SERVICE BULLETIN MAINTENANCE OF WAY EQUIPMENT

DATE: 10 - 2007			BULLETIN NO: 07-014
TITLE: 3412227 Stub A	xle Service Group		
RATING:	ALERT (Potential Problem)	X	INFORMATION (Action Is Optional)
	DIRECTIVE (Action Is Required)		PRODUCT IMPROVEMENT (Enhance Product)

PRODUCT SERIES / MODEL: HR1500 Series B HY-RAIL® Guide Wheel Units.

Installing New Stub Axle - See Figures 2 and 3

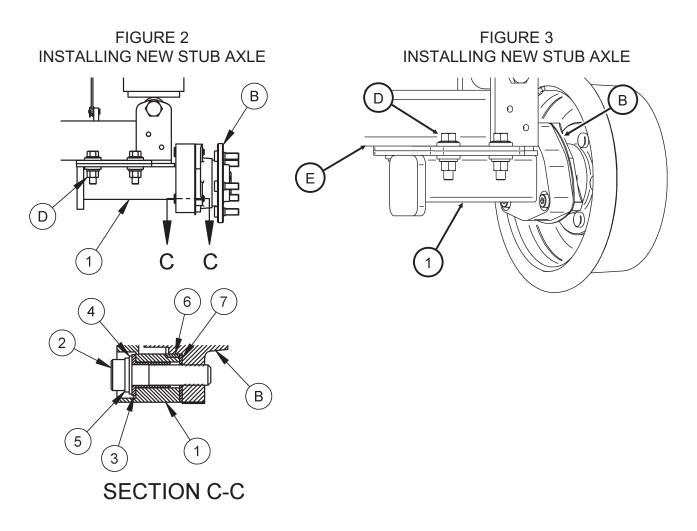
- SERIAL NO: N/A
- **SUMMARY:** It has come to the attention of Harsco Track Technologies that there is a clearance problem between the stub axle on the HR1500 Series B Guide Wheel Unit and a newly designed high lift frog. Therefore, Harsco Track Technologies has developed a new stub axle to help correct this problem. If you are experiencing clearance problems with the original stub axle in special track structures, Harsco Track Technologies recommends that you install the 3412227 Stub Axle Service Group.

Installing New Stub Axle - See Figures 2 and 3

- 1. Place the new stub axle in a vice and assemble the integral spindle and wheel to it before mounting it to the axle assembly.
- 2. Place the three insulating bushings (3) inside the three holes in the stub axle (1).
- Place the insulating plate (7) and Insulating bushing (6) on to the integral spindle (B).
 Place the integral spindle (B) on stub axle (1) and secure with flat washers (4), lock washers (5) and socket head cap screw (2). Coat the cap screw threads with Loctite 242 Blue (8) before inserting. Torque the cap screws (2) to 60 lb-ft (80 N-m). Check to ensure that there is no continuity between the guide wheel and the stub axle.

- 4. If the guide wheel unit is equipped with grease guards, the grease guards will need to be modified by removing some material to allow installation of the new stub axle.

- 5. Secure the stub axle (1) to the axle assembly (E) using hex nuts, bolts and washers (D).
- 6. After replacing both stub axles on the common axle assembly, the guide wheel unit back flange gauge will have to be set. Measure from the back of the left wheel flange, directly below the center line of the wheel spindle, to the same point on the right wheel flange. This dimension must be 53-3/8 53-1/2 inches (1356 1359 mm).
